**City of Springfield
Development and Public Works Department**

August 14, 2014

**Addendum Number 3 to the Contract Documents for the
Invitation to Bid for P21101; Downtown Lighting – Phase 1**

PROJ #	P21101
SHEET #	SL1-6

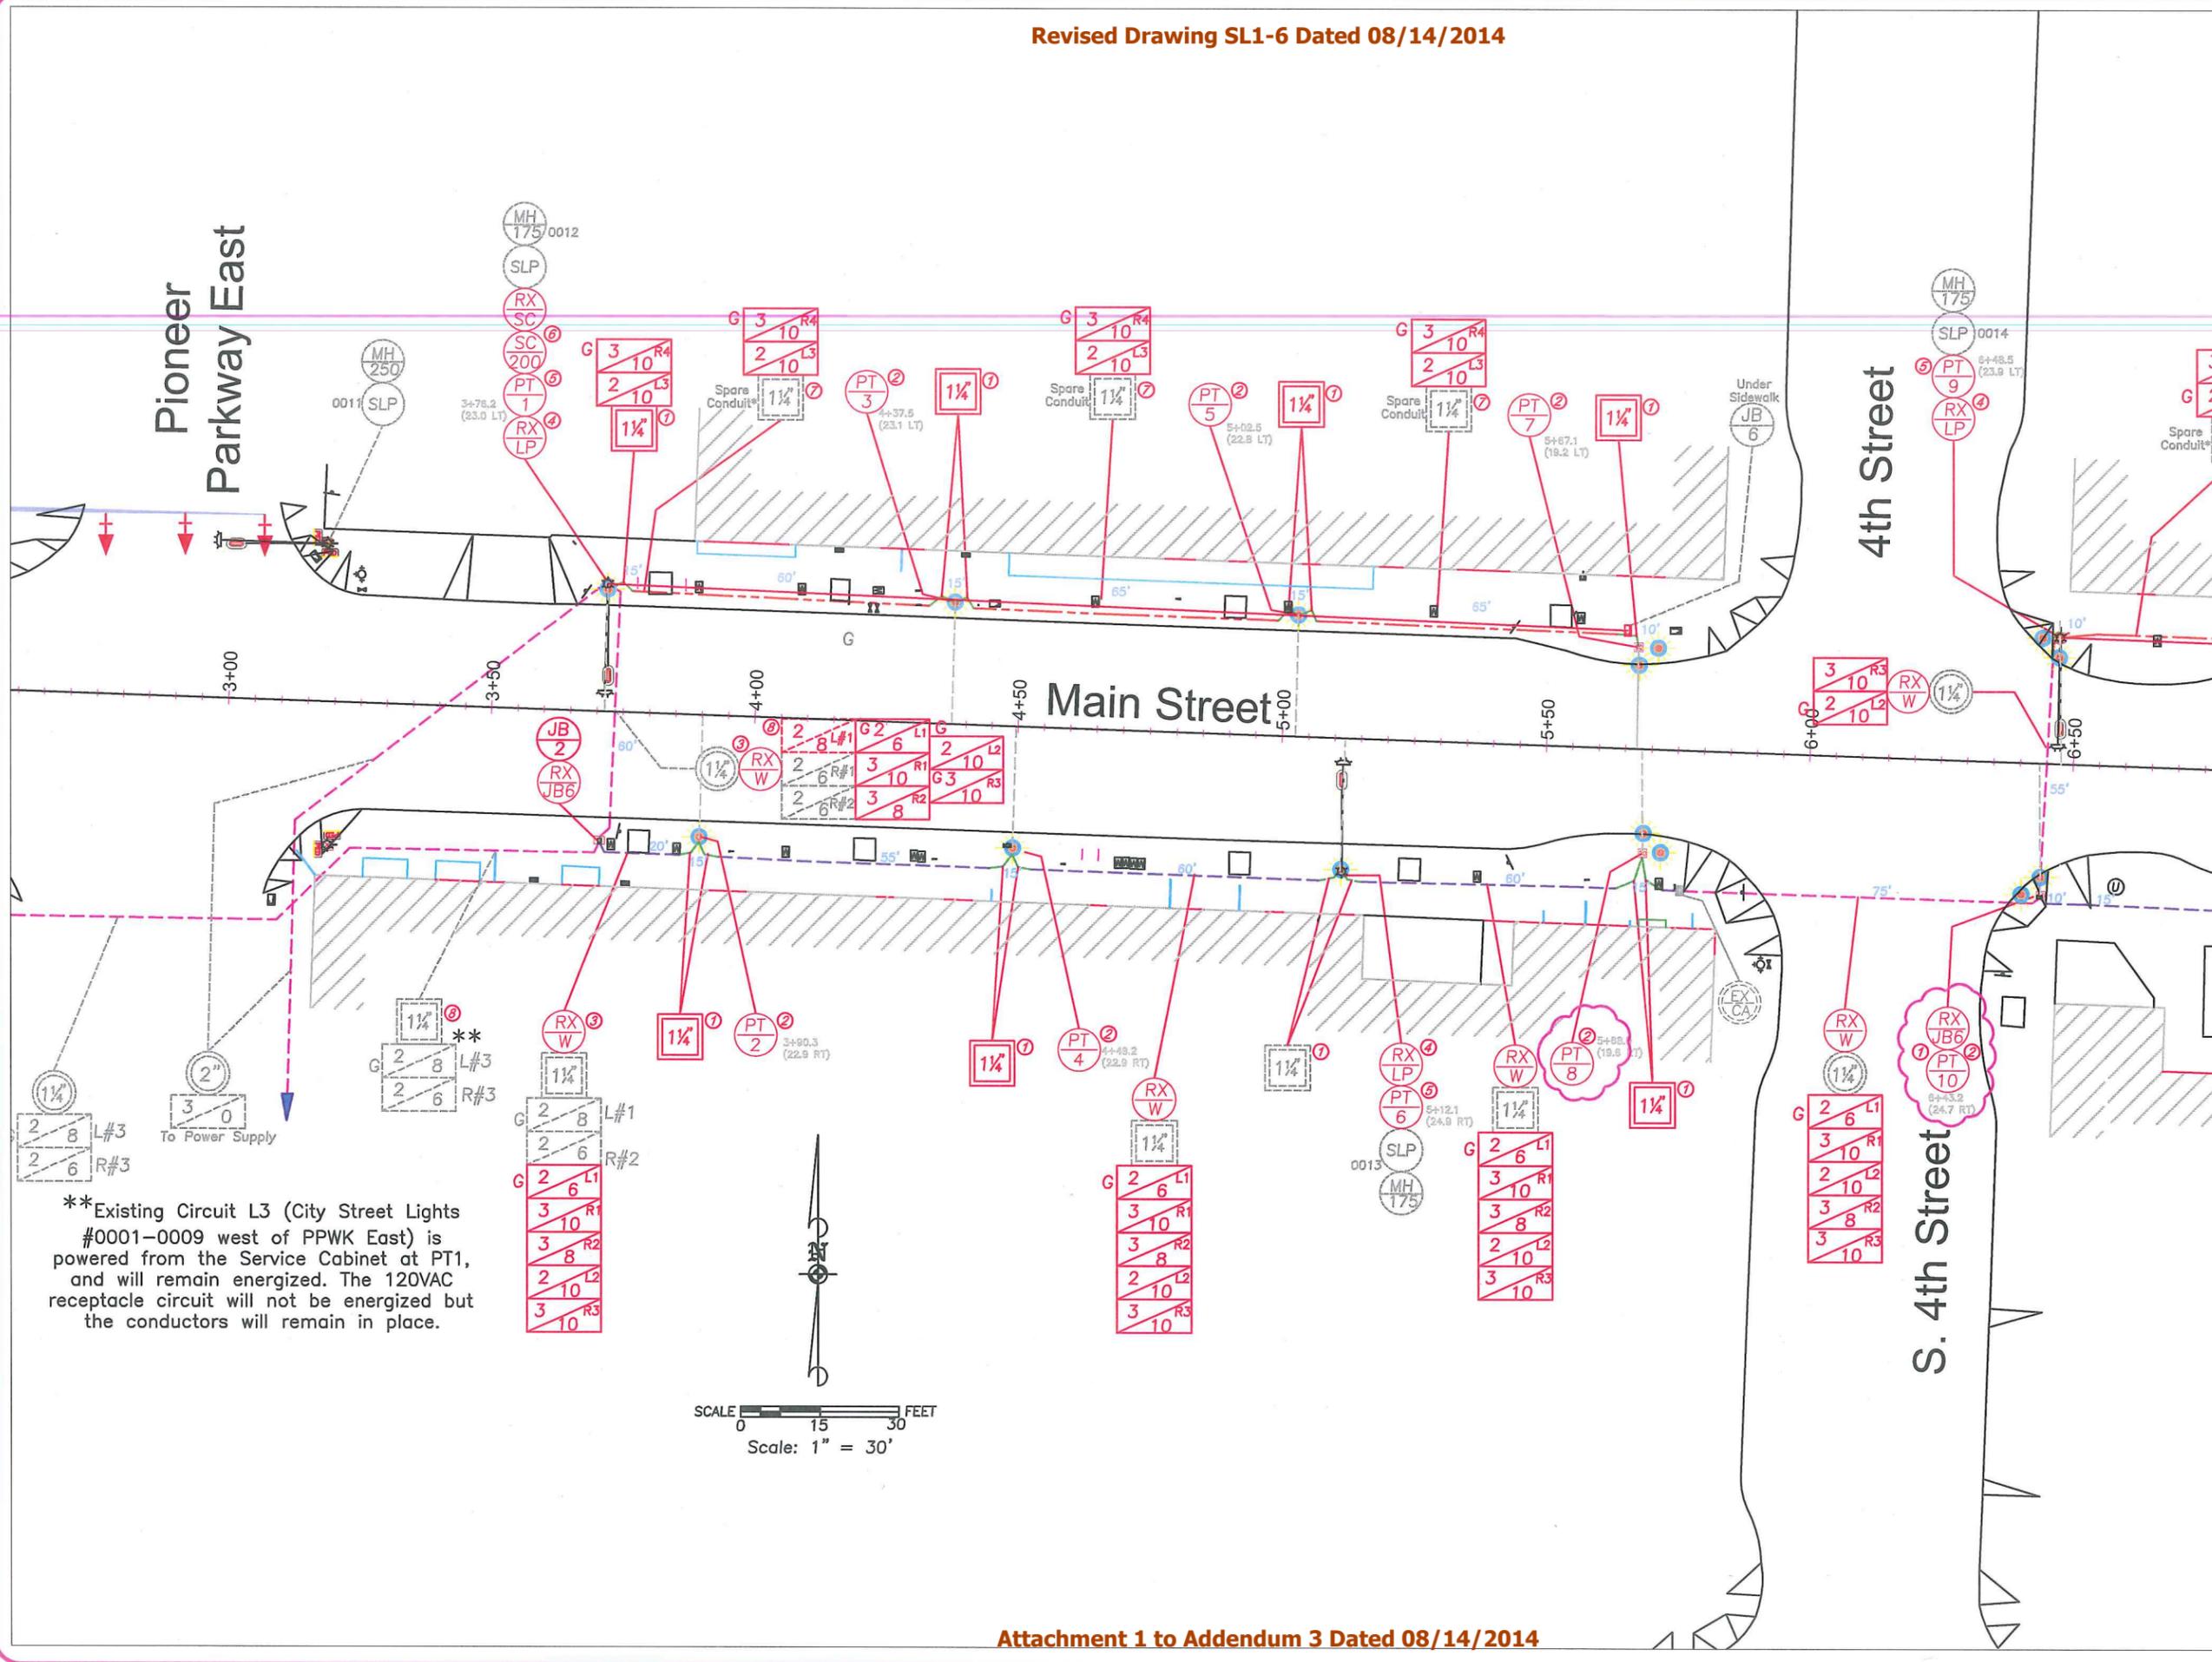
- 3.) The deadline for submission of questions is being changed from August 13, 2014 at 12:00 p.m. to August 20, 2014 at 12:00 p.m.
- 4.) Drawing SL1-6 Illumination Plan is deleted in its entirety and is being replaced with Drawing SL1-6 Illumination Plan with a revision date of 08/14/14. Note 1 for PT/10 and Note 2 for PT/8 were added. See Attachment 1 to this addendum.

NO	REVISION	DATE	BY	APPR
1	Added Note & PT8 B/L2 DRE BFB Cloud Revision	8/12/14	DRB

PROJ # P21101
 SHEET # SL3-6

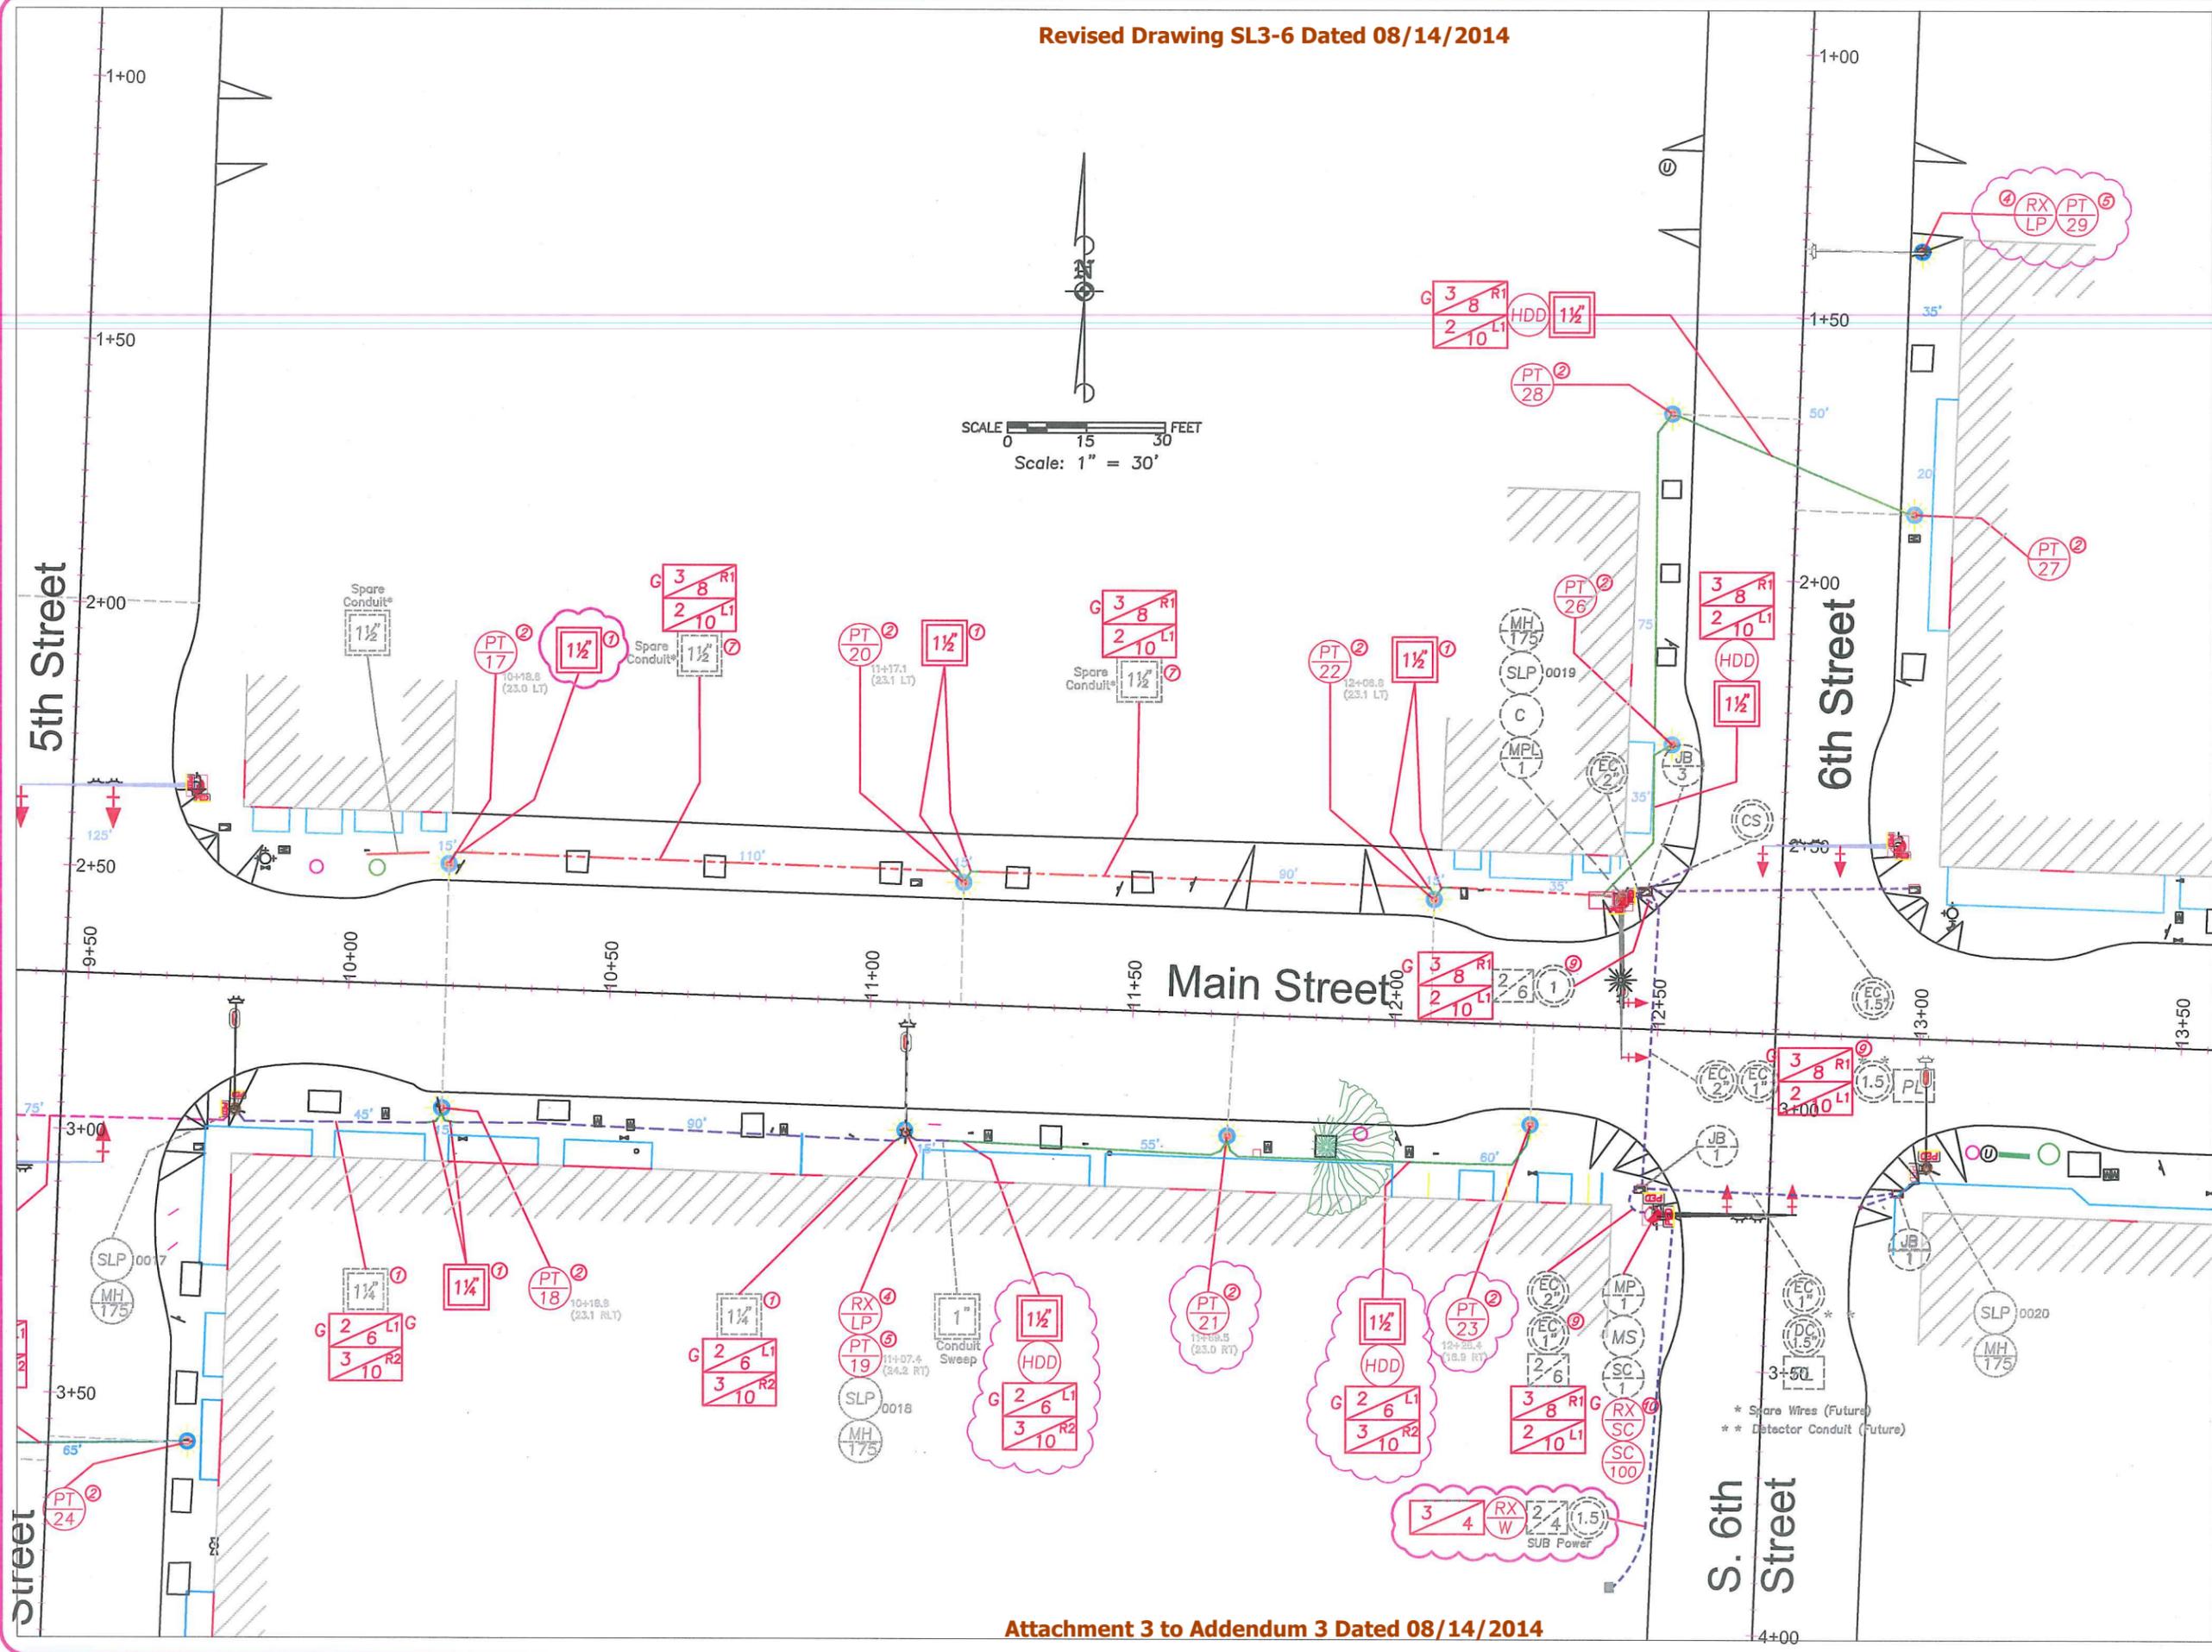
- 6.) Drawing SL3-6 Illumination Plan with a revision date of 08/04/14 is deleted in its entirety and is being replaced with Drawing SL3-6 Illumination Plan with a revision date of 08/14/14. Added conduit and Note 1 at PT/17. Added HDD Notes at PT/19, PT/21 and PT/23. Added RX/LP Symbol and Note 4 at PT/29. See Attachment 3 to this addendum.

NO	REVISION	DATE BY	APPR.
1	HDD & RX/LP Cloud Revision	8/14	BFB
1	Added Note 2 PT21 & PT23	8/12	BFB

PROJ # P21101
SHEET # SL5-6

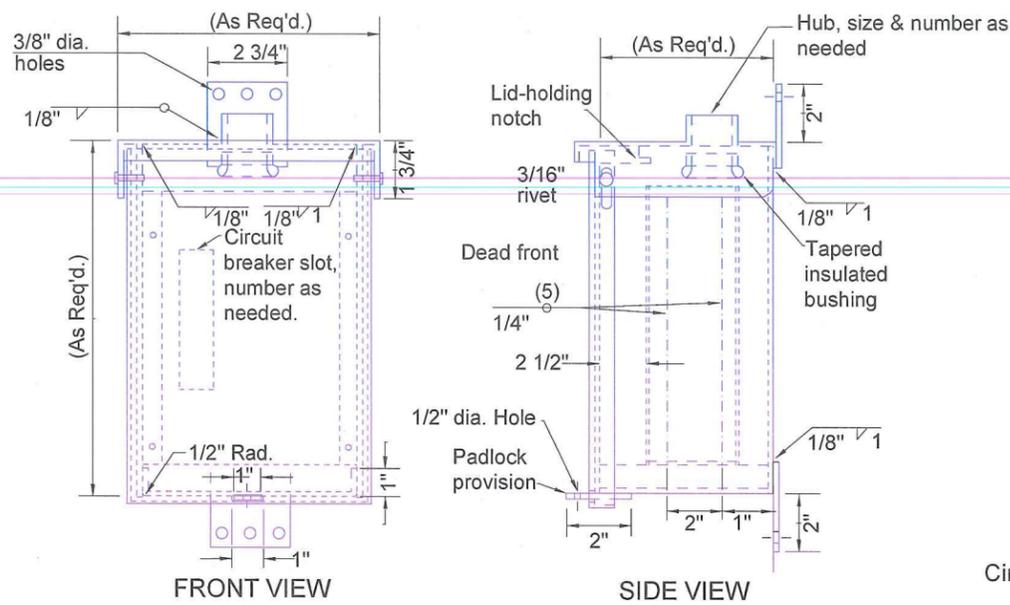
- 7.) Drawing SL5-6 Light Pole Table is deleted in its entirety and is being replaced with Drawing SL5-6 Light Pole Table with a revision date of 08/14/14. Added base type changes to Poles 19 and 20. Added base type F note to Pole 28. See Attachment 4 to this addendum.

NO	REVISION	DATE	BY	APPR.
1	PT19, 20 & 28 Base fix Cloud Revision	8/12/14	BFB

PROJ #	P21101
SHEET #	SL-TM427

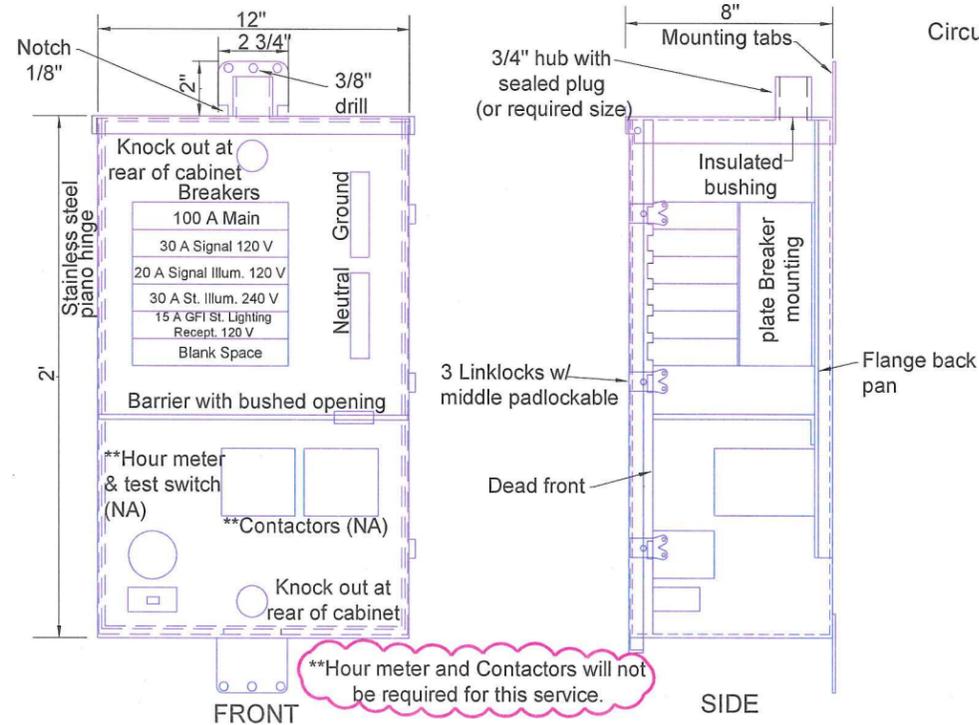
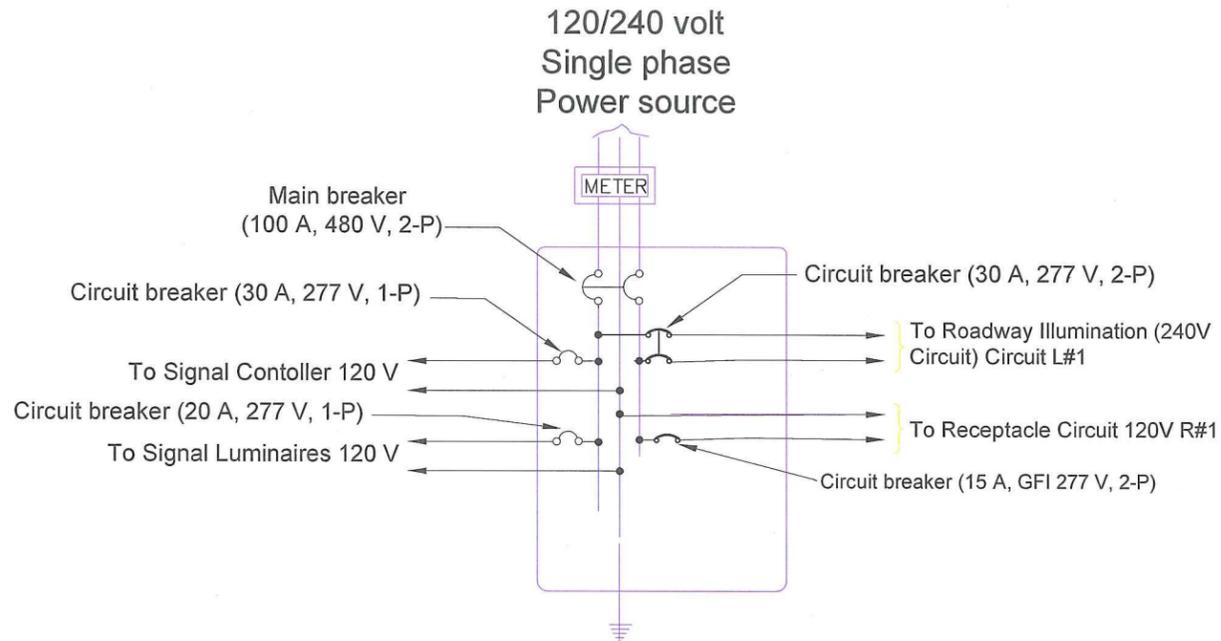
- 8.) Drawing SL-TM427 Service Cabinet dated 08/04/14 is deleted in its entirety and is being replaced with Drawing SL-TM427 with a revision date of 08/14/14. Added Note "Hour meter and Contractors will not be required for this service". See Attachment 5 to this addendum.

**Hour meter and Contactors will not be required for this service.
